BALTIMORE COUNTY PUBLIC SCHOOLS

ADDENDUM NUMBER 2

BID NAME: NEW SCHOOL CONSTRUCTION LANSDOWNE ELEMENTARY SCHOOL
DEMOLITION OF LANSDOWNE ELEMENTARY SCHOOL

BID NUMBER: **MBU-516-17**

ADD. NO.2
SK-S-3

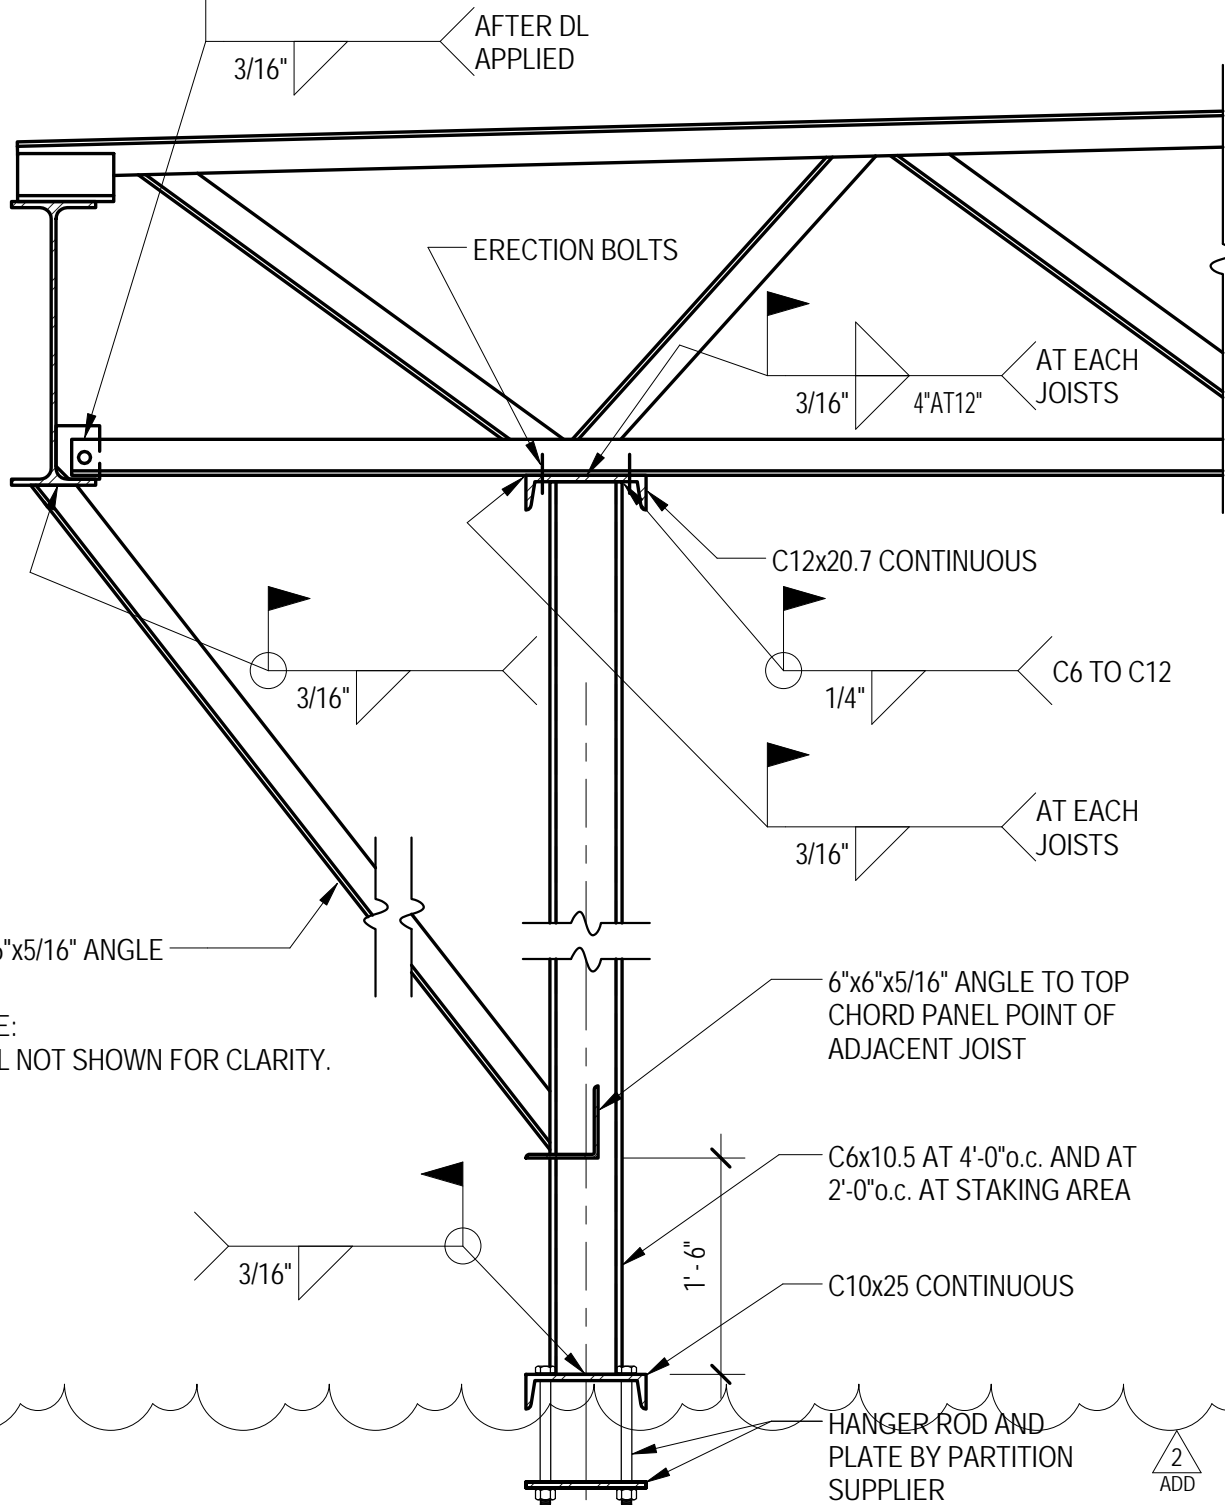
- 5.10. SHEET S-5.1, SECTIONS
REVISE Section G/S5.1 per attached sketch SK-S-2.
- 5.11. SHEET S-5.2, SECTIONS
REVISE Section A/S5.2 per attached sketch SK-S-3.

SK-S-4

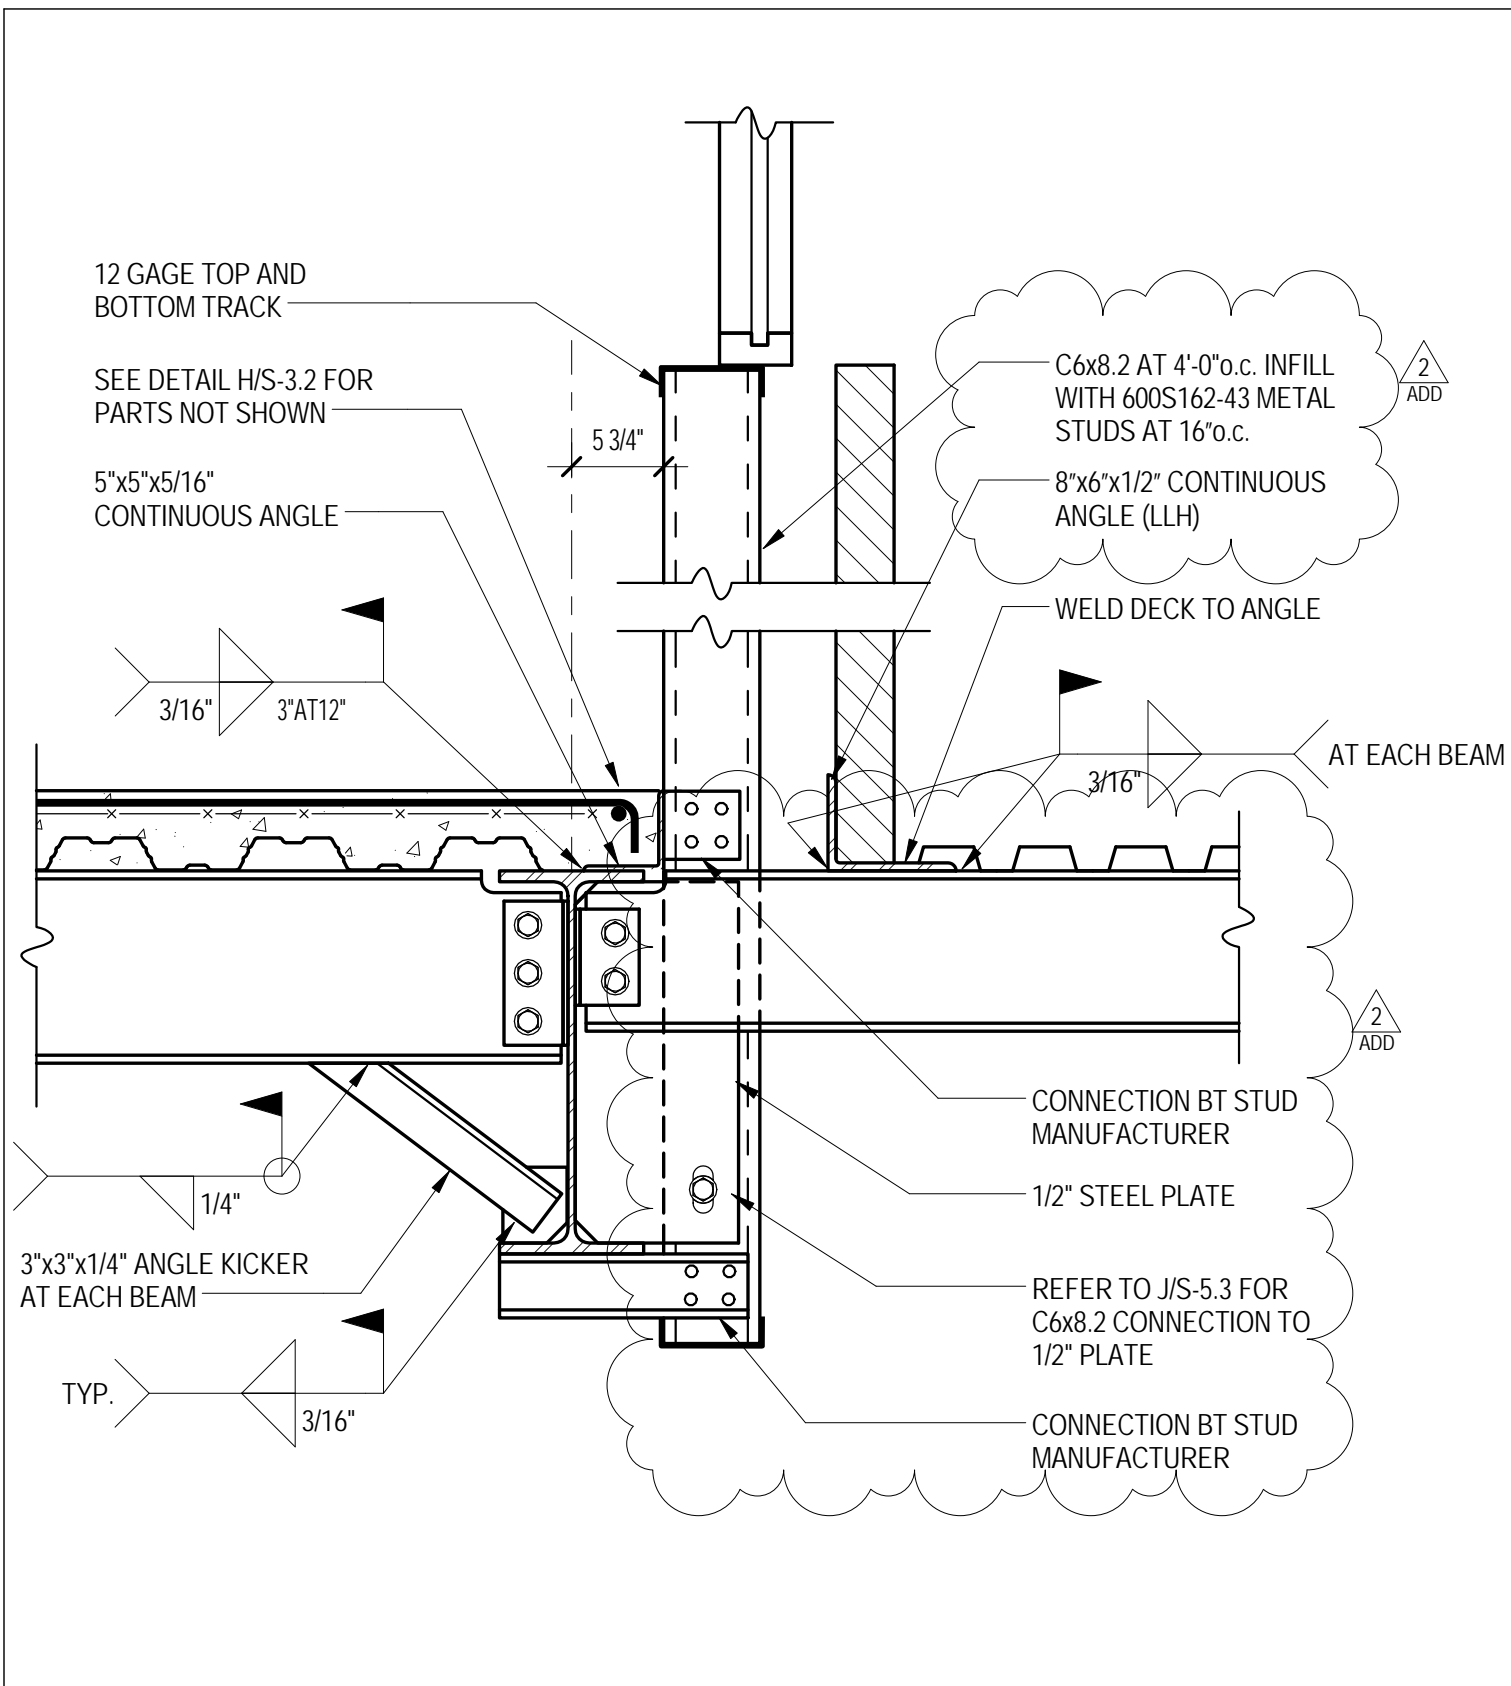
- 5.12. SHEET S-5.3, SECTIONS
REVISE Section J/S5.3, to show the distance of 5"x5"x5/16" continuous angle from bottom track to be 1'-4".
REVISE Section H/S5.3 per attached sketch SK-S-4.
REVISE Section F/S5.3 to show brick veneer with 8"x8"x1/2" continuous angle cut and trim as required at similar. The 600S162-54 studs at 16" o.c. to read, "600 S162-54 studs at 16" o.c. with top and bottom track. C6x8.2 at 4'-0" o.c. with 600S162-54 stud infill at 16" o.c. at similar. 1/4" weld for angle to channel is provided at top of angle. 3/16" weld is provided on both sides of angles to channel. 1/2" steel plate is provided and note, "Refer to detail J/S5.3 for C6x10.5 to 1/2" steel plate at similar."

SK-S-5

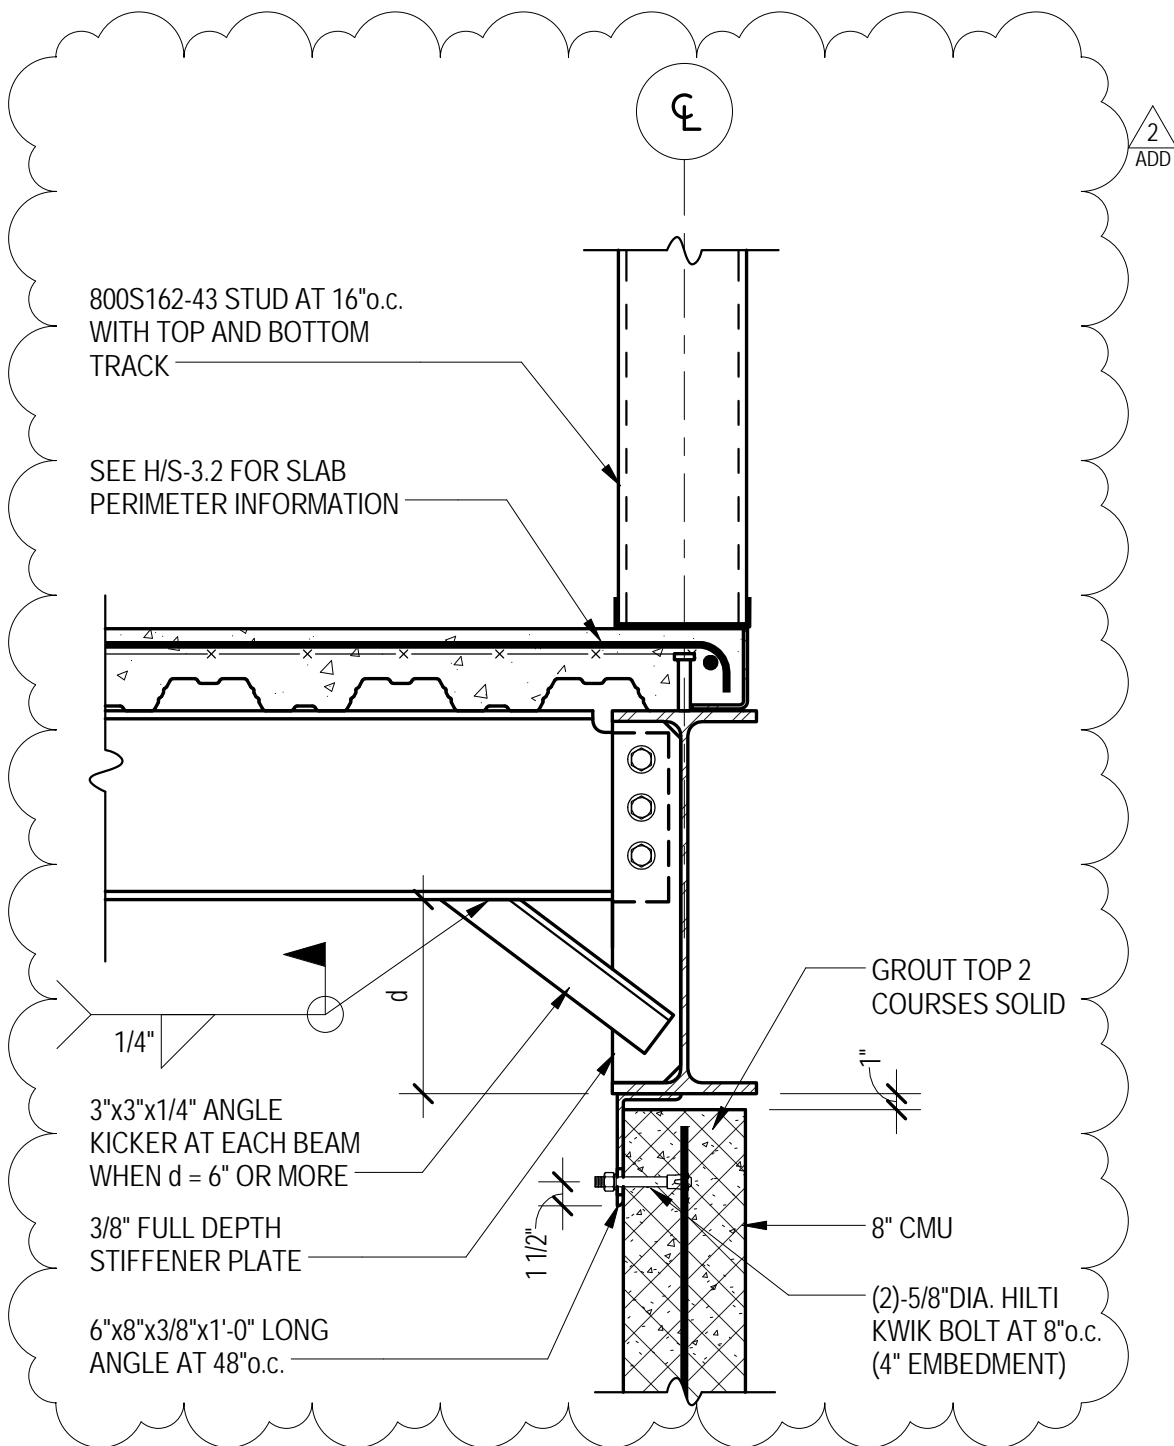
- 5.13. SHEET S-5.4, SECTIONS
REVISE Section A/S5.4 to show CMU wall extending past the high roof and the 12"x3"x5/16" bent plate to 5"x3"x1/4" bent plate continuous.
REVISE Section J/S5.4 per attached sketch SK-S-5.

SK-S-6

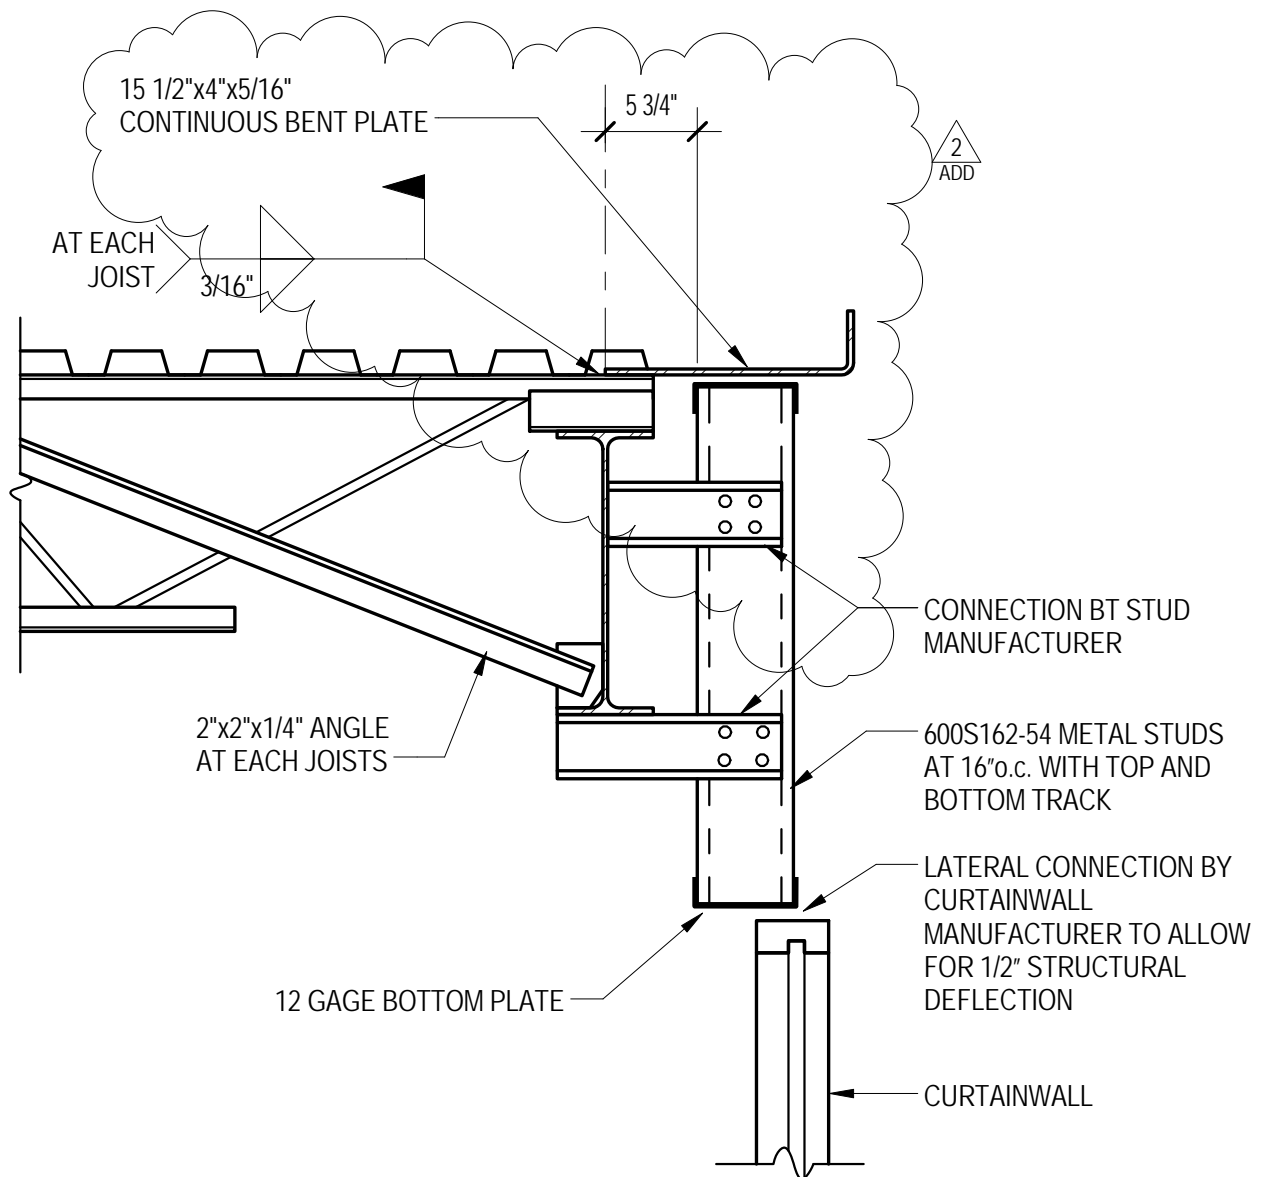
REVISE Section K/S5.4 per attached sketch SK-S-6.
REVISE In section L/S5.4, dimension 7" max to read 8-3/4".

ADD. NO.2
SK-S-8

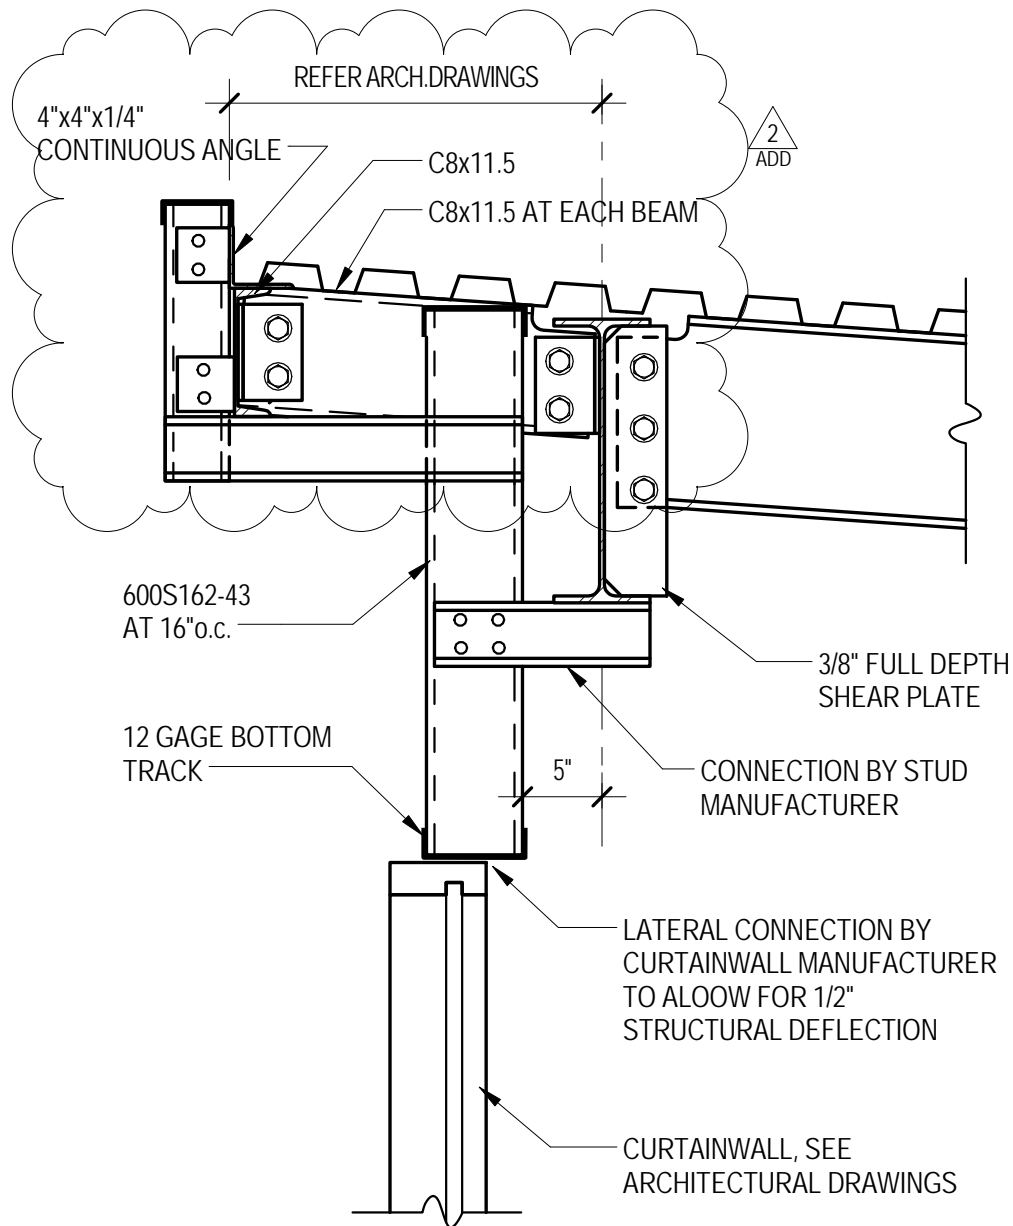
REVISE Section G/S5.5 per attached sketch SK-S-7.
REVISE Section K/S5.5 per attached sketch SK-S-8.
REVISE Section M/S5.5, CMU wall to end below roof deck and the bent plate from 4"x4"x5/16" to 15.5"x4"x3/8". Roof deck extends over the top of CMU wall.

SK-S-9

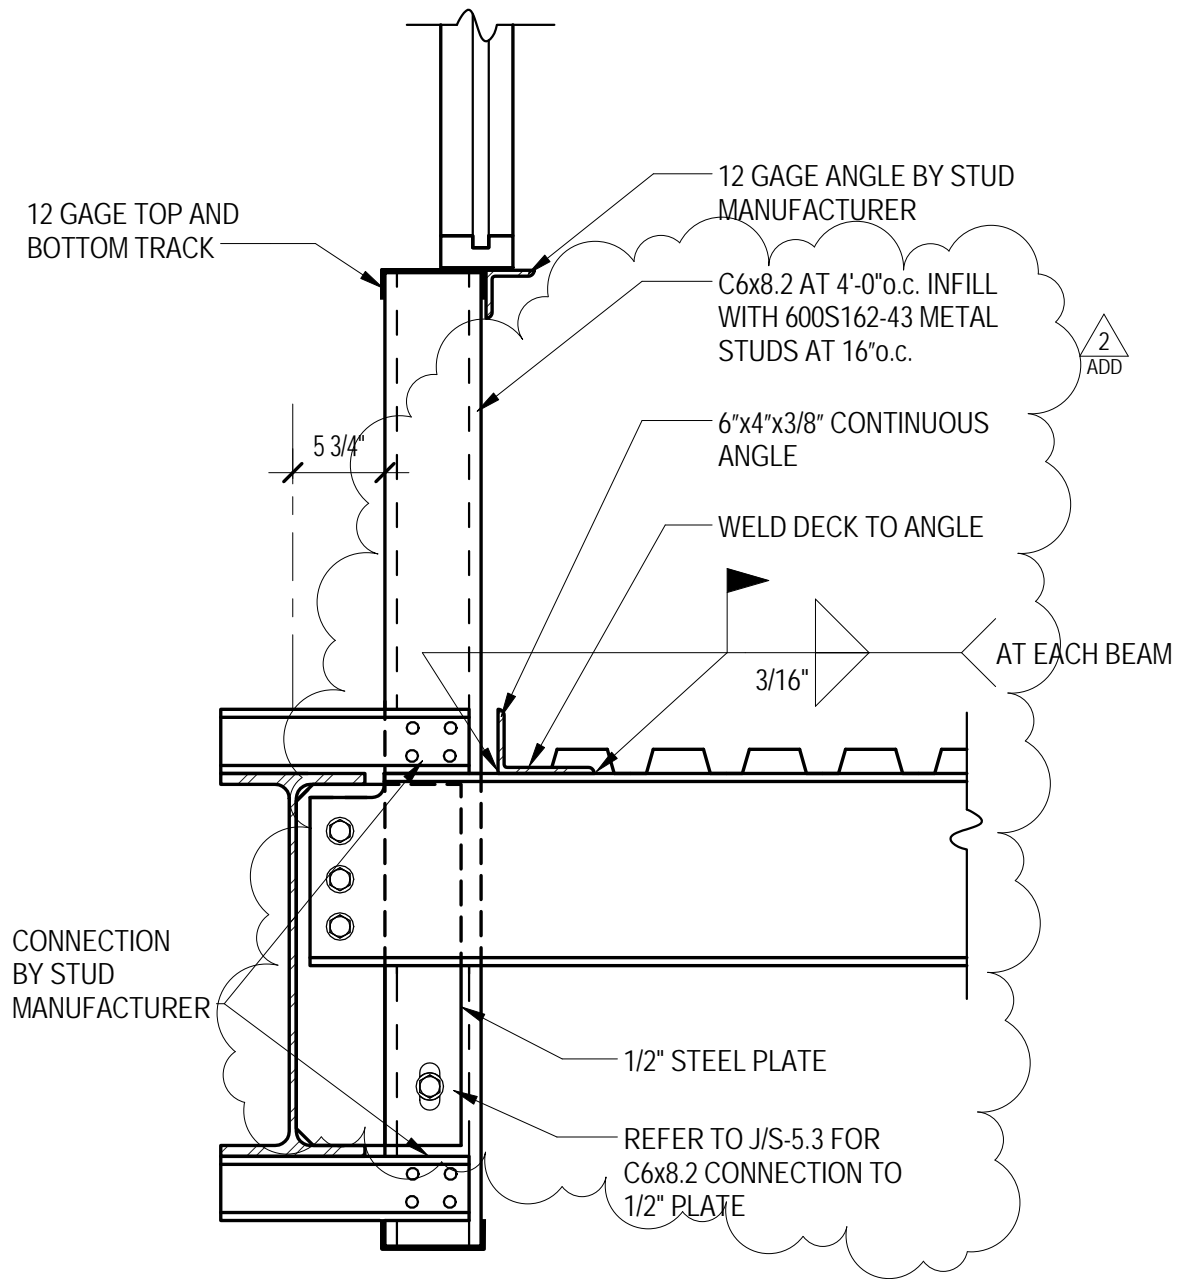
REVISE Section G/S5.6 per attached sketch SK-S-9.
REVISE Section H/S5.6 per attached sketch SK-S-10.
ADD Section J/S5.6 per attached sketch SK-S-11.
ADD Section K/S5.6 per attached sketch SK-S-12.
